Service Manual

NISSAN Motor Genuine
2DIN HDD Navigation

The original model of UQY7793/4/5,UQY7803/4/5 is UQY6102. This additional service manual is designed to be used together with the service manual of UQY6102.

8.Differance parts list

Drawing-30

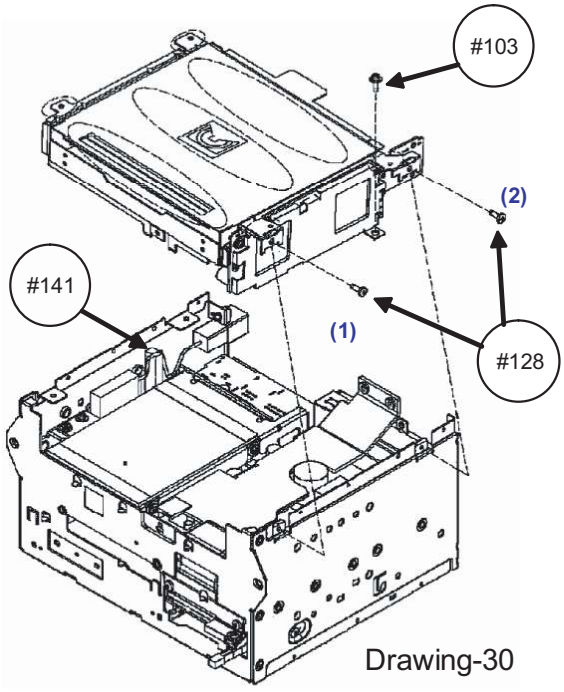
Please confirm it about the additional part (#141) in the following ASSEMBLY DRAWING and ASSEMBLY PROCEDUER.

PAGE	NO.	PART NO.	DESCRIPTION	QT'Y
6	#112	.8829035A	AUDIO PWB AS	1
	#114	.9900403A	NAU-US-V2 PWB	1
10	#141	MUZ1971	ANT sheet (add)	1
	#127	MQZ0321	HDD2 sheet	1
11	#130	.8829012A	XM-PWB-Assy for UQY7803/4/5	1
	#135	MQZ0103	TUN sheet	1

PROCEDURE	NOTICE
3.Stick the(#141)ANT sheet on the processed AUDIO PWB ASSY (Drawing-30) and lay out GPS-ANT cable.	※Through the SHEET ANT upper part. (Drawing-24)
